802.1Qbc Provider Bridging – Remote Customer Service Interface draft 0.0 status

Main Items for Discussion

Common Port

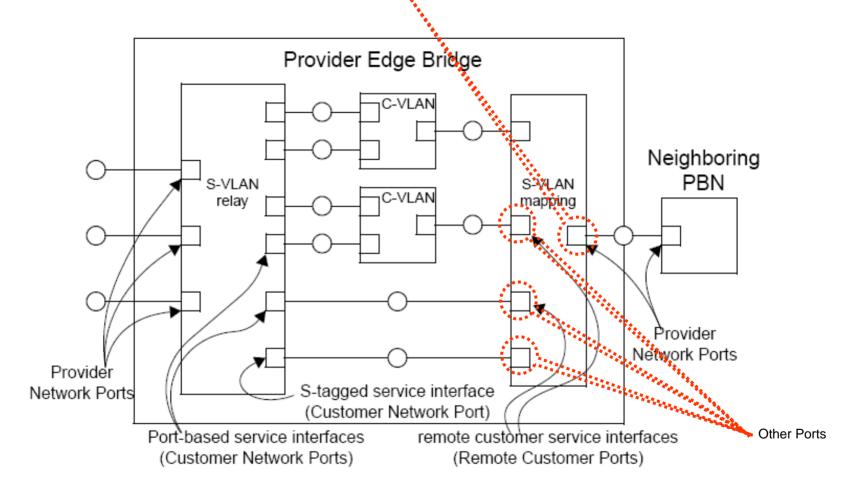
- Terminology
 - "S-VLAN mapping component" (66, 23, 56, 26, 60)
 - "common port"(22, 29, 23, 49, 36, 2, 46)
 - "remote customer service interface"(20, 43, 53, 10, 33, 44, 5)
 - Port role names(53, 71, 11, 6, 53, 64)
- Number of external ports (3, 31)
 - How to provide protection
- Number of S-VLAN tagged internal ports (9, 34)
- Interface Status TLV (editor's note, 40, 72)
